**Preferred Project Report  
For Project Application At  
No. 6-16 Atchison Street, St Leonards**

**On Behalf Of  
Bancor Developments Pty Ltd**

**April 2011**

**Figure 1: East and West Elevation Comparison**

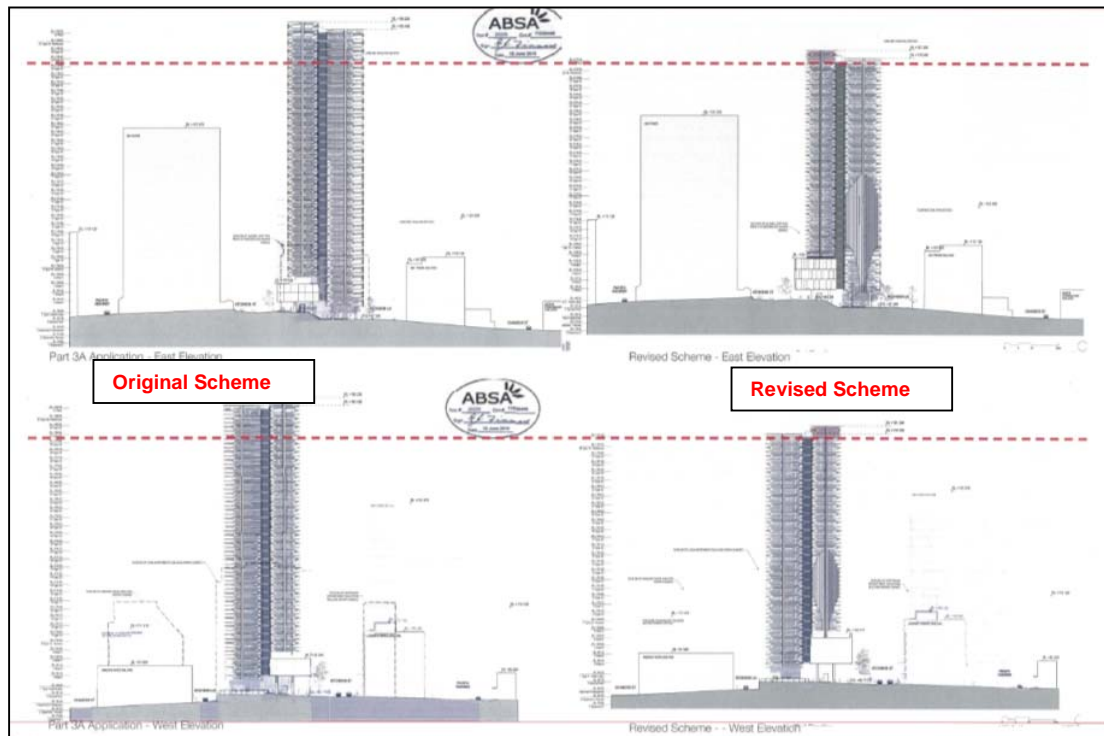
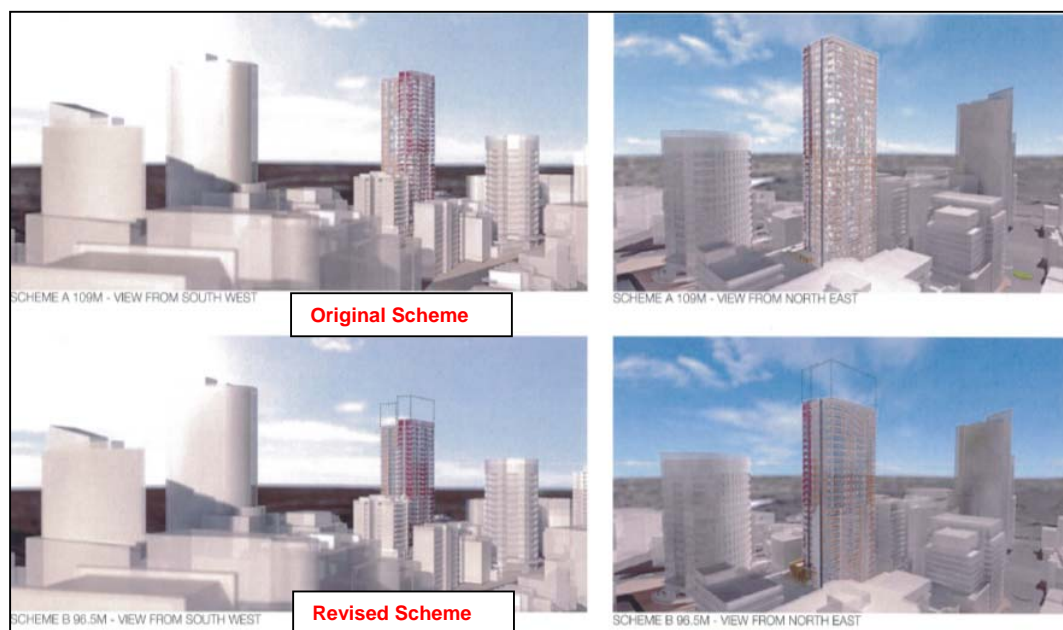
- The maximum height of the proposed development was reduced by 12.5m (4/5 storeys) from 109m to 96.5m;
- The unit mix and minimum unit sizes was amended and unit numbers reduced from 228 to 173 and an increase in Hotel rooms from 38 to 76;
- Deletion of the pool;
- Revised facade to accommodate apartment changes and SEPP 65 issues including privacy screens to the eastern and western facade;
- Revised podium height – now 4 levels (including ground level) consistent with the Linea building (No. 12 Atchison Street); and
- Reduction in number of carparking and basement levels in order to reflect reduced number of units.

Images of the scheme under the EA and the revised scheme under the PPR is provided below for comparison purposes refer to Architectural plans attached at **Appendix 2** for detail.

**Figure 4: Proposed podium from Atchison Street (reproduced here)**

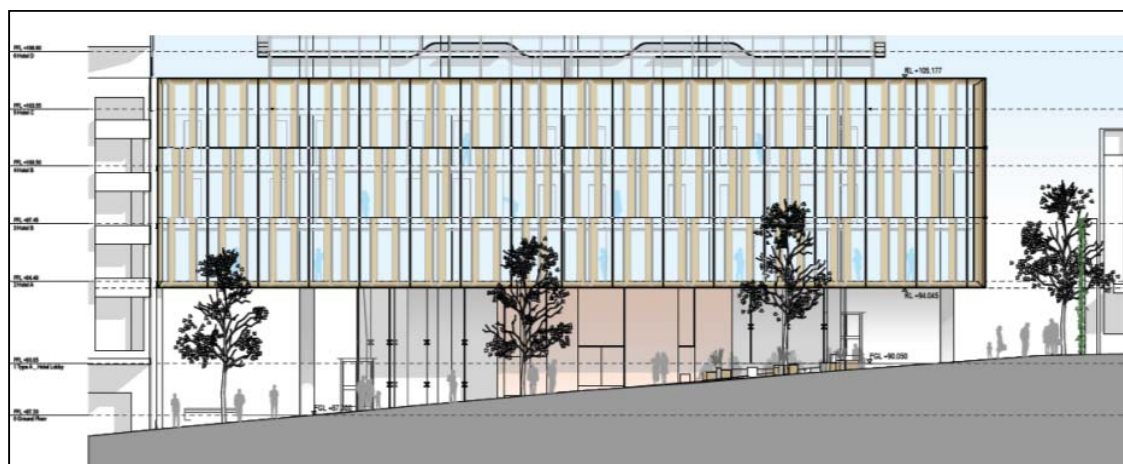
*Consideration should be given to extending the podium form over the western portion of the site and to the south to Atchison Street. Podium heights should match the podium height of the adjacent “Linea” building to the west.*

*This analysis should include a consideration of the partial enclosure of the ground floor frontage to Atchison Street to activate the streetscape and relocation of the fire stairs and service utilities to a less prominent part of the Atchison Street frontage. Options for increasing the setback of the podium to the eastern (side) boundary should also be provided."*

The design as submitted with the EA Report included a 3 level podium (including recessed ground floor). This was amended as part of the PPR to present as 4 levels (including recessed ground floor) consistent with the Linea Building (see **Figure 4**).

The design as submitted with the EA Report included a 3 level podium (including recessed ground floor). This was amended as part of the PPR to present as 4 levels (including recessed ground floor) consistent with the Linea Building fronting Atchison Street.

**Figure 8: Additional Shadow analysis on the Abode**

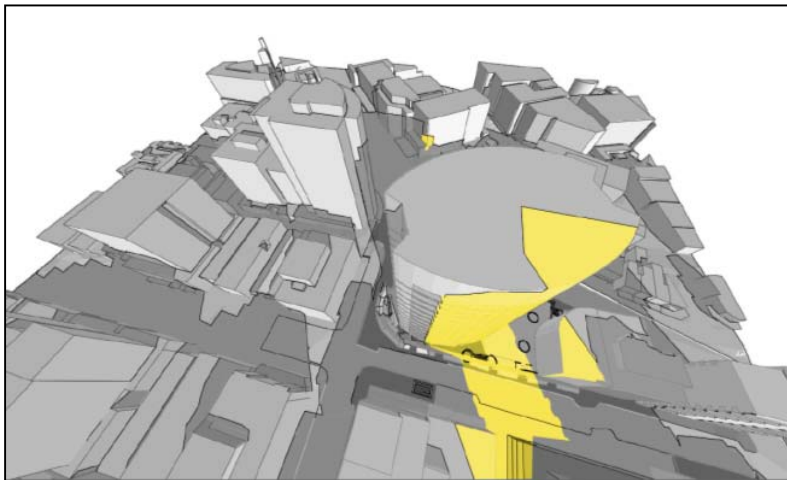
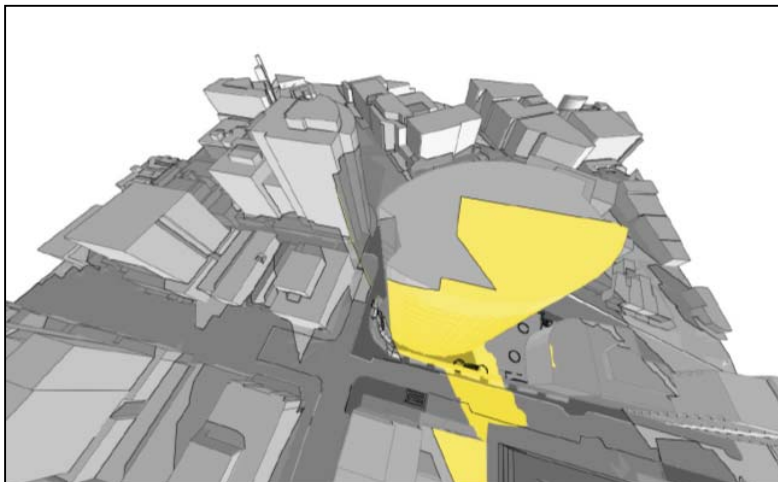
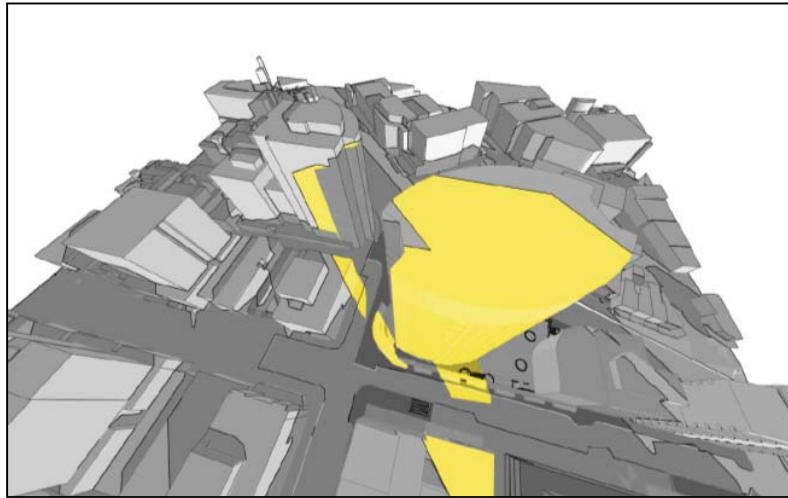
*“A shadow analysis detail the shadow cast by the proposed building on the Abode building (in elevation format).”*

The proponent has undertaken additional shadow analysis on request of DoPI in order to demonstrate any additional shadow cast by the proposed building on the Abode building. In this respect, additional detailed solar analysis of the shadow impact on the Abode between 2pm and 3pm at 5 minute intervals was undertaken (see **Appendix 3**). Additional shadow was only investigated for the period 2-3pm at the Winter Solstice as this is the only time the proposed building cast shadow on the Abode.

From earlier analysis submitted with the EA Report as well as the additional analysis undertaken, it is noted that the proposed development creates only minor additional late afternoon overshadowing. This additional shadow only occurs from 2.30pm onwards during mid-winter to apartments which already incur overshadowing from the IBM tower (see **Figure 8** below and **Appendix 3** for more detail).

It is estimated that the proposed development will only affect approximately 20 units between Levels 3 and 12 on the northern elevation of the Abode building only. Notably these units receive full sunlight for the period 9am to 1:30pm (4.5 hours) mid-winter when the IBM building starts casting a shadow.

As stated above the proposed additional shadow as a result of the proposed development is limited to less than 30min at mid-winter after 2:30pm (the shadow before that period is within the existing shadow of the IBM building), and as such the affected units maintain access to sunlight well in excess of 2 hours required.
